ADDENDUM NUMBER ONE
CHATTANOOGA PUBLIC LIBRARY – CHILLER AND BOILER IMPROVEMENTS
CONTRACT NO. L-18-001
JANUARY 25, 2019
CITY OF CHATTANOOGA, TENNESSEE

The following changes shall be made to the Request for Bids:

Public Library Chiller and Boiler Improvements

HVAC PIPING - BOILER/CHILLER

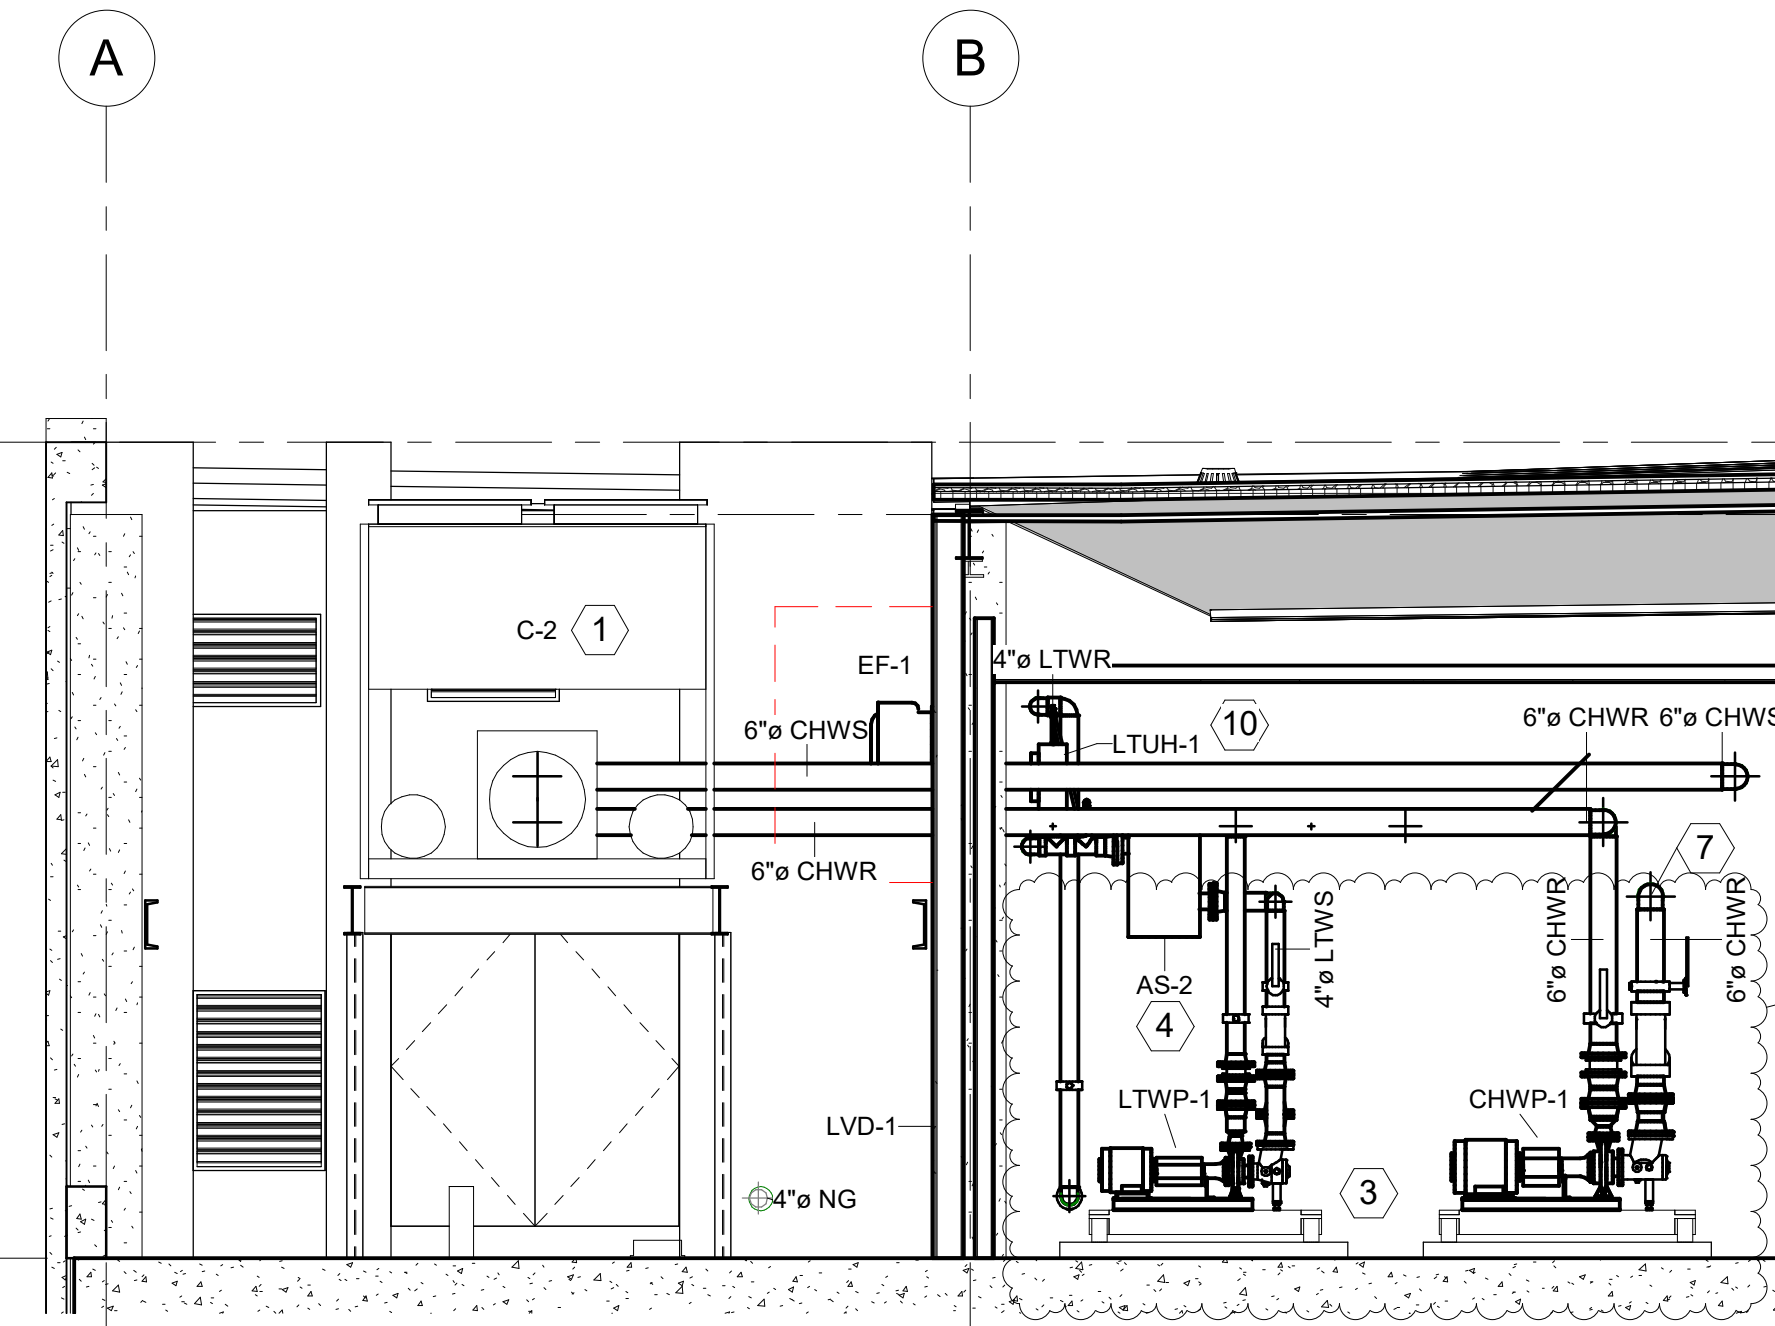
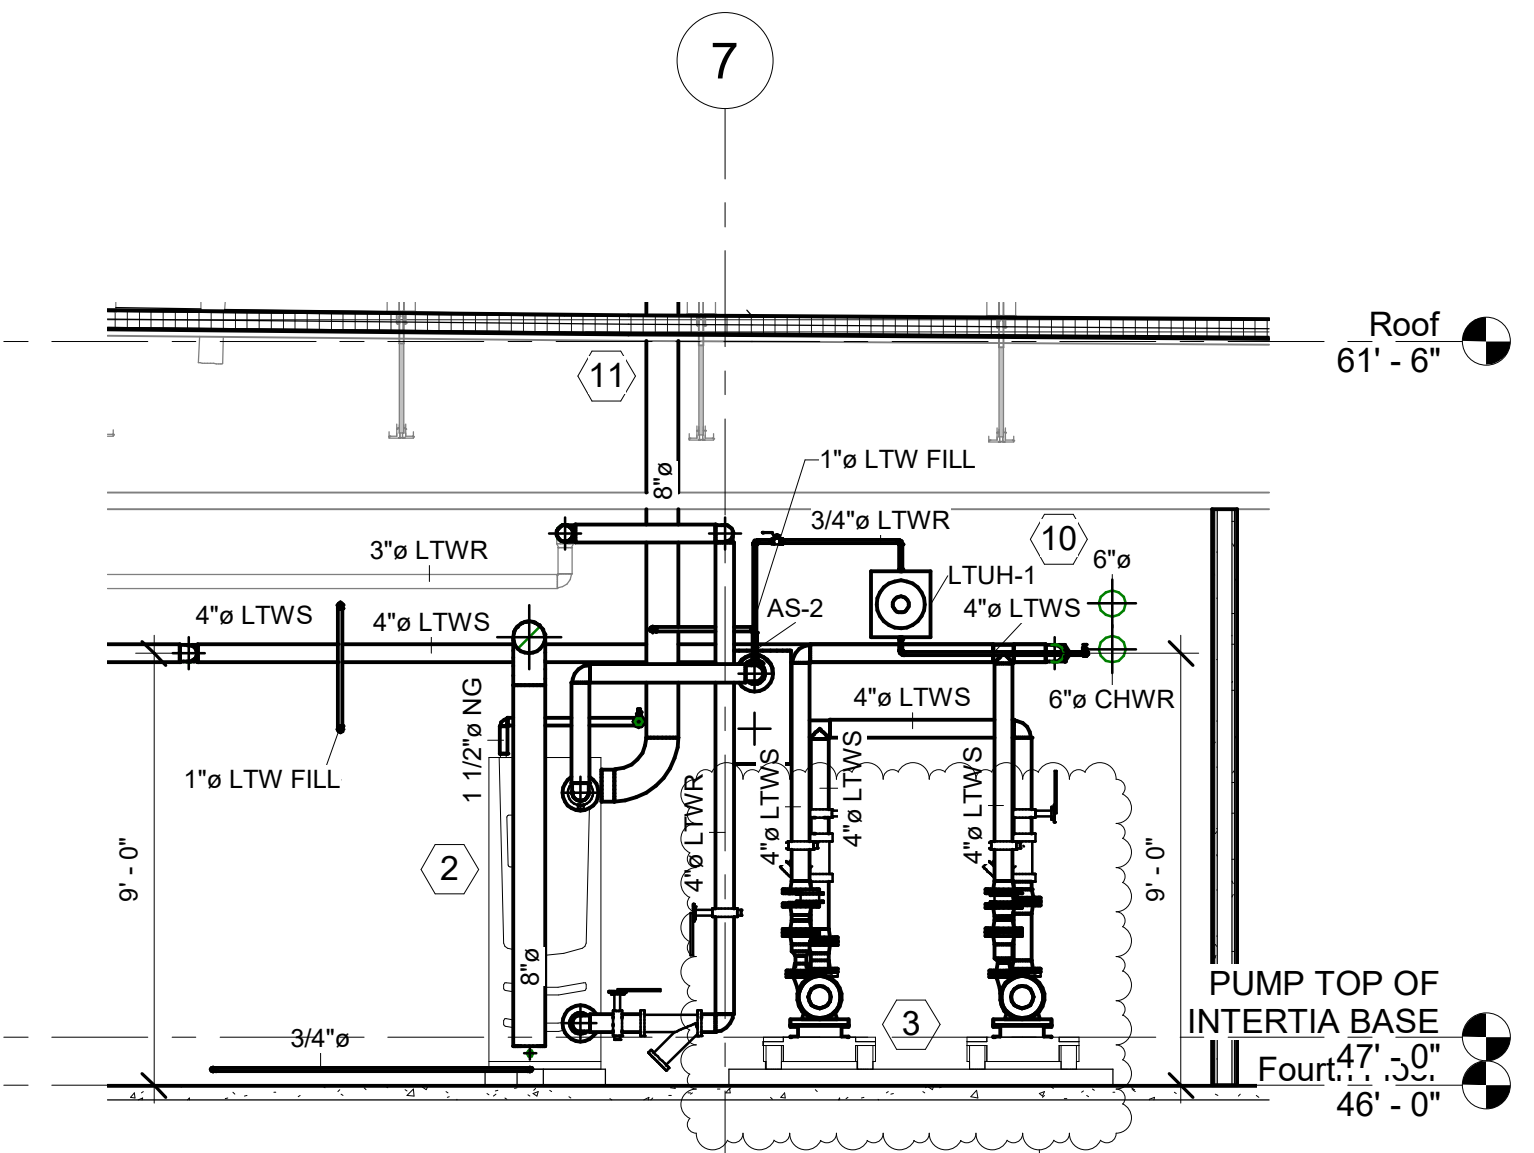
- c. Sheet A-342 Housekeeping Pad Details (new sheet) is issued as part of this addendum and indicates details of the housekeeping pads.
- d. Sheet M-206 HVAC Piping Boiler / Chiller is re-issued as part of this addendum and describes changes to the housekeeping pads and piping locations.

- C. INERTIA BASE + PUMP SHALL BE INSTALLED ON 4" MIN. SERVICE PAD, EXTENDING 6" ON ALL SIDES OF INERTIA BASE. SERVICE PAD SHALL INCLUDE VIBRATION PAD - SEE ARCHITECTURAL DETAIL FOR MORE INFORMATION ON SERVICE PADS.
